UNITED STATES  
NUCLEAR REGULATORY COMMISSION  
WASHINGTON, D. C. 20555

APPLICANT: Arizona Public Service Company  
FACILITY: Palo Verde Nuclear Generating Station, Units 4 and 5  
SUBJECT: SUMMARY OF MEETING HELD ON OCTOBER 17, 1978 REGARDING THE  
SAFETY REVIEW OF PALO VERDE, UNITS 4 AND 5

REQUEST FOR ADDITIONAL INFORMATION

SUBJECT 80-Acre Storage Reservoir Failure Flood Study Checked By M. Warner

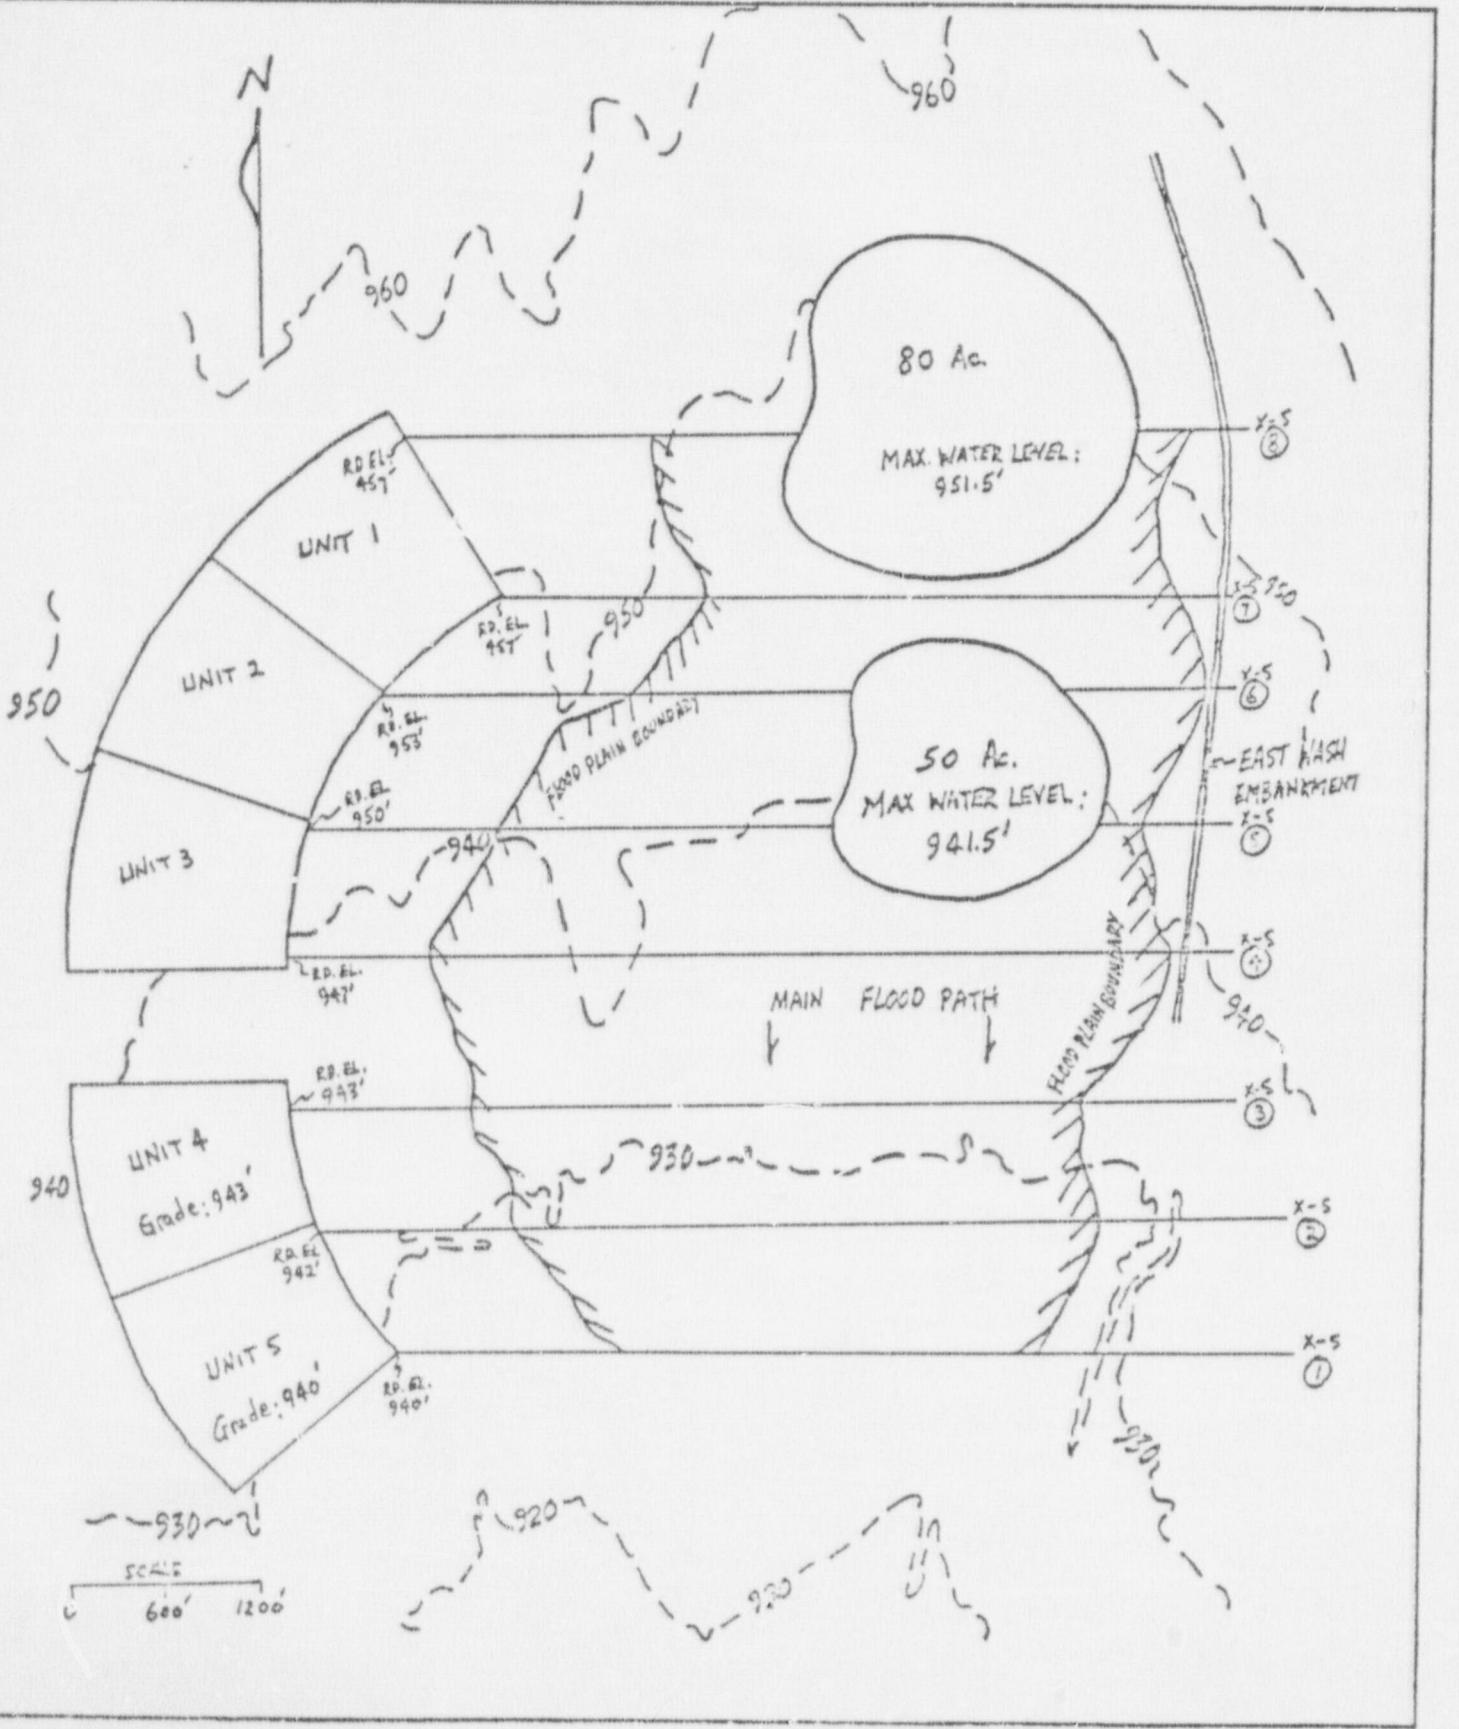
Provide the cross sections used in determining the extent of flooding during a postulated failure of the 80 acre reservoir. Provide documentation of the methods used to determine the starting water level used in the backwater analysis and the peak discharge of the dam-break wave. Provide the basis for your analysis and for all assumptions used in determining the water surface profile at the plant, including as a minimum, Mannings "n" values, slopes, transition losses and routing coefficients.

The proposed Units 4 & 5 plant site is located about 6000 feet southwest of the 80-acre storage reservoir (see attached drawing). The terrain between the plant and the reservoir has a slope of about 0.0037 descending in a general north-to-south direction. In the event of a postulate failure of the 80-acre storage reservoir, the main flood path would be in the low valley stretch located between the East Wash embankment and the Unit areas. The 80-acre storage reservoir has a maximum design water level of 951.5 feet which is 9.5 feet above the ground grade of 942 feet. This above-ground portion of water, approximately 738 ac-ft.,

- 1) A total of eight (8) cross-sections (see attached drawing) were used to represent the land terrain characteristics.
- 2) Field reconnaissance has shown that the Manning "n" coefficient of the land surface ranges from 0.035 to 0.050. For conservative purpose, a Manning's n of 0.05 was used.
- 3) The starting water level was estimated by the model using the slope-area method. The initial energy slope was approximated by using the average land slope (0.0037).

An iterative process was applied to input various peak discharges into the model until the total water volume under the calculated backwater flood profile is equivalent to the total above-ground water, 738 ac-ft., stored by the reservoir. When this condition is satisfied, the reservoir is considered to be drained out and the resulting backwater curve represents the maximum flood level downstream from the reservoir. In the calculation for the 80-acre reservoir break-down, a peak discharge of 150,000 cfs was observed to back up a total volume of 898 ac-ft of water. For conservative purpose, further attempts to reduce the total water volume to 738 ac-ft were not made.

The flood plain resulting from this 150,000 cfs peak discharge was delineated on the attached drawing. As shown, the maximum flood elevations approaching Units 4 & 5 are about 936 feet and 927 feet, respectively. Compared with the design plant grade of 943 feet at Unit 4 and 940 feet at Unit 5, it may be concluded that Units 4 & 5 are not subject to flooding due to failure of the 80-acre storage reservoir.
